UNITED STATES PATENT AND TRADEMARK OFFICE

APPLICATION NO.	FILING DATE	FIRST NAMED INVENTOR	ATTORNEY DOCKET NO.	CONFIRMATION NO.
10/628,718	07/28/2003	Helmut Kadmoska	WBW-12002	6749
24131	7590	05/06/2004	EXAMINER	
LERNER AND GREENBERG, PA P O BOX 2480 HOLLYWOOD, FL 33022-2480			SCHULTERBRANDT, KOFI A	
			ART UNIT	PAPER NUMBER

Office Action Summary

DETAILED ACTION

2,277,738

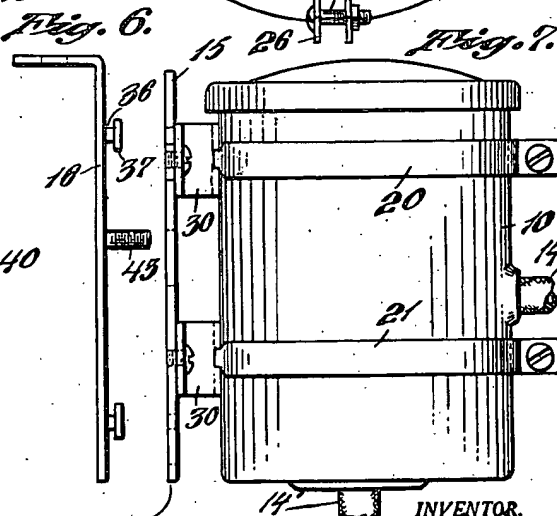
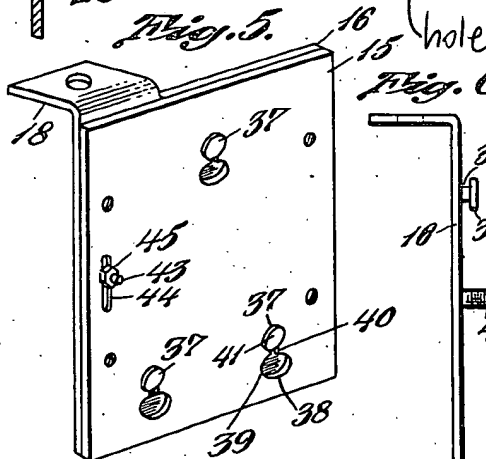
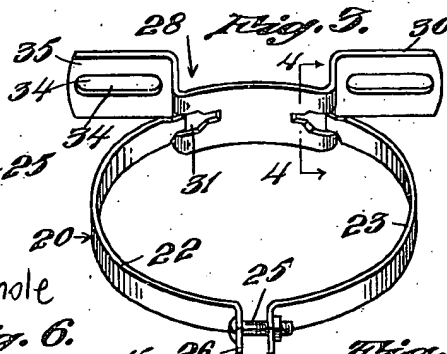
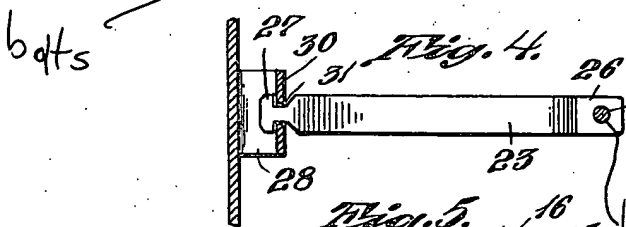
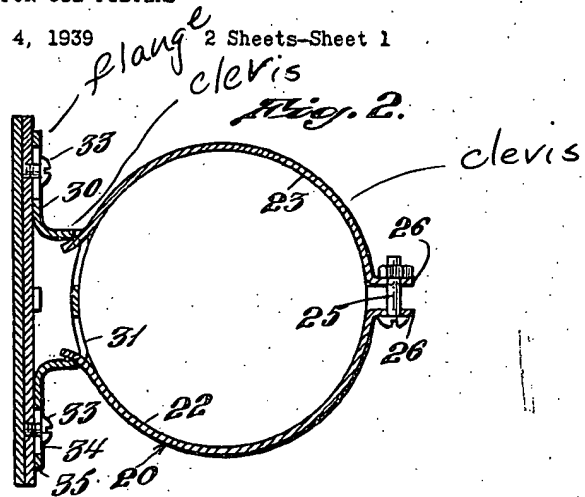
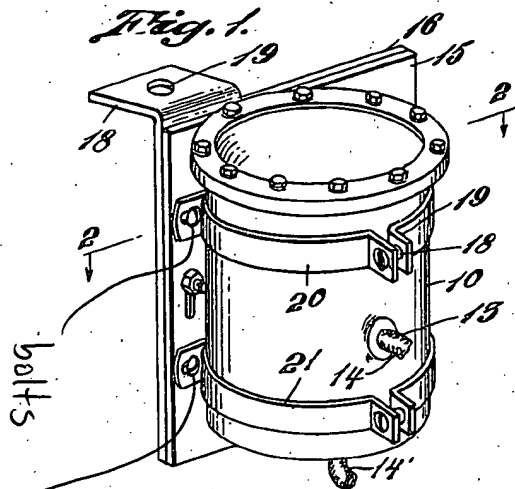
Claims 1-10 are rejected under 35 U.S.C. 103(a) as being unpatentable over Wilkinson (2,277,738), in view of Byerly (4,338,707). Wilkinson teaches, substantially, each feature of the claimed invention as shown in the attached marked-up copy of Wilkinson's Figures 1-7. Wilkinson does not teach a conduit for receiving the line material or an elongated hole in a first one of the parts. Byerly however teaches a conduit/liner (30) for cushioning the contact between the cable or pipe to be supported and the support. It would have been obvious to one of ordinary skill in the art at the time of invention to have modified Wilkinson to have a lining along Wilkinson's the clevis members (22 and 23) to form a conduit as taught by Byerly in order to cushion the contact as taught by Byerly. Regarding claim 4, if Byerly's duct (30) is formed in the shape of Wilkinson's clevis members (22), its ends will be inwardly bent. It would also have been obvious to one of ordinary skill in the art at the time of invention to have modified Wilkinson's hole to be elongated to increase the flexibility of positioning as taught by Wilkinson's flange hole (34) to make insertion and positioning of Wilkinson's journal (25) easier.

Claims 15-19 are rejected under 35 U.S.C. 103(a) as being unpatentable over Wilkinson (2,277,738), in view of Byerly (4,338,707) and Taft (928,711). Wilkinson teaches, substantially, each feature of the claimed invention as shown in the attached marked-up copy of Wilkinson's Figures 1-7. Wilkinson does not teach a conduit for receiving the line material or an elongated hole in a first one of the parts. Byerly, however, teaches a conduit/liner (30) for cushioning the contact between the cable or pipe to be supported and the support and Taft teaches the polygonal shape. It would

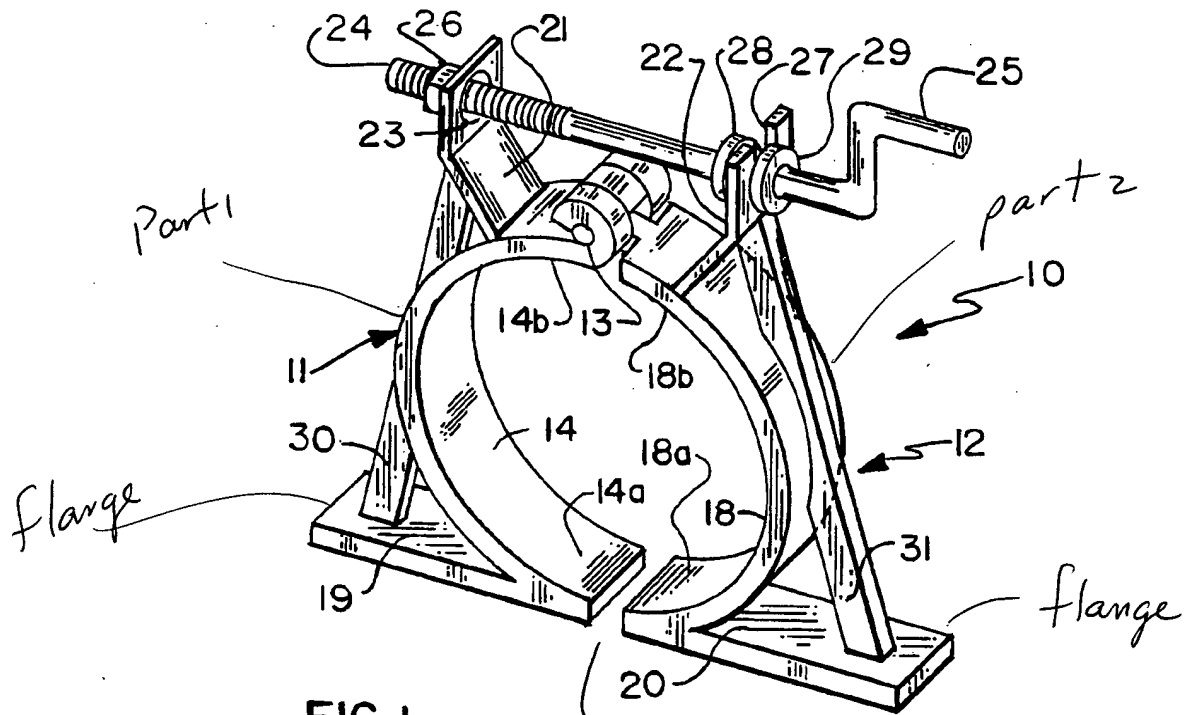
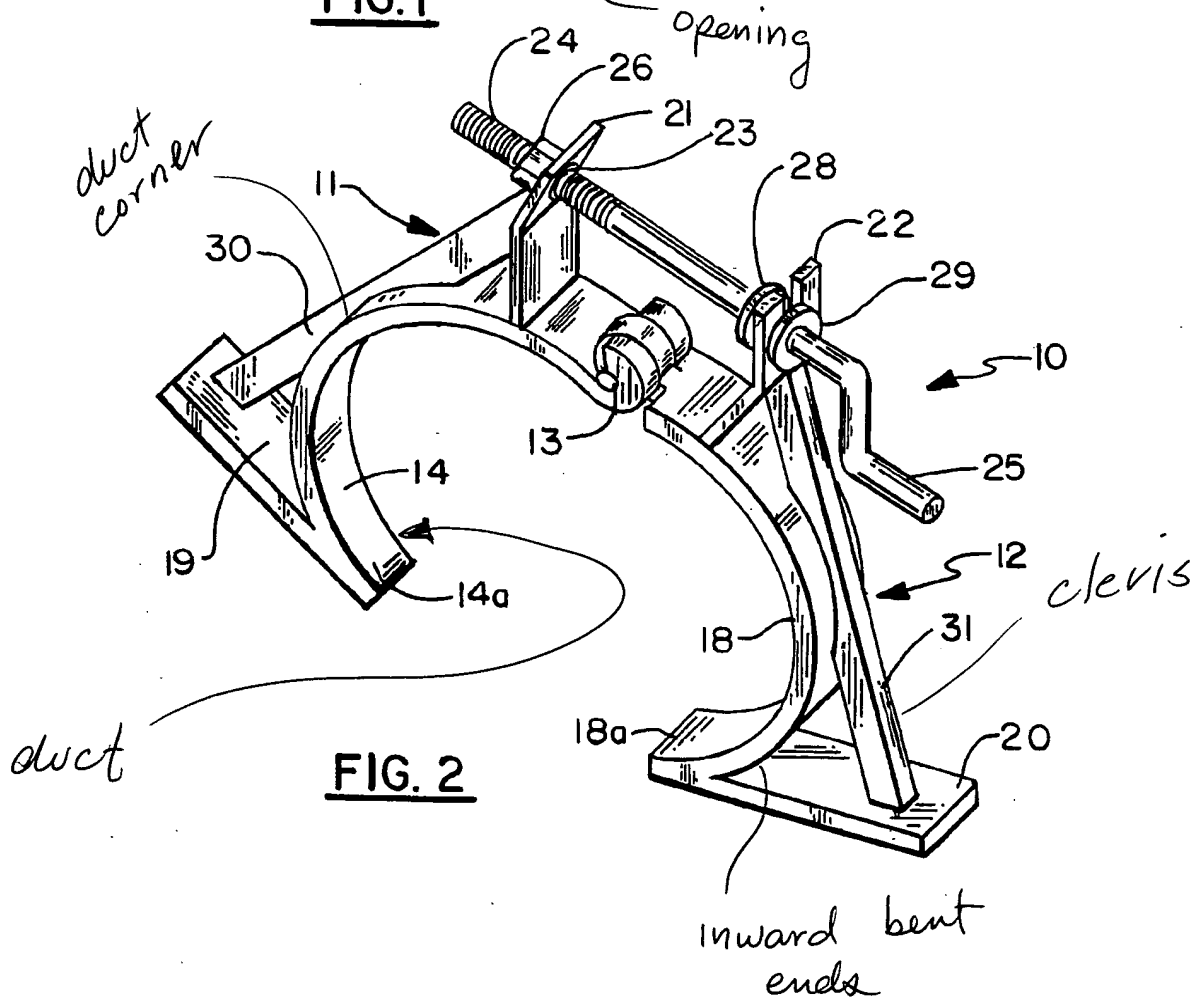
Claims 1-4 and 11-14 are rejected under 35 U.S.C. 102(b) as being anticipated by Schlenker (5,462,246). Schlenker teaches each feature of the claimed invention as shown in the attached marked-up copy of Schlenker's Figures 1 and 2. Regarding claim 12, Schlenker's duct includes (14) and (35).
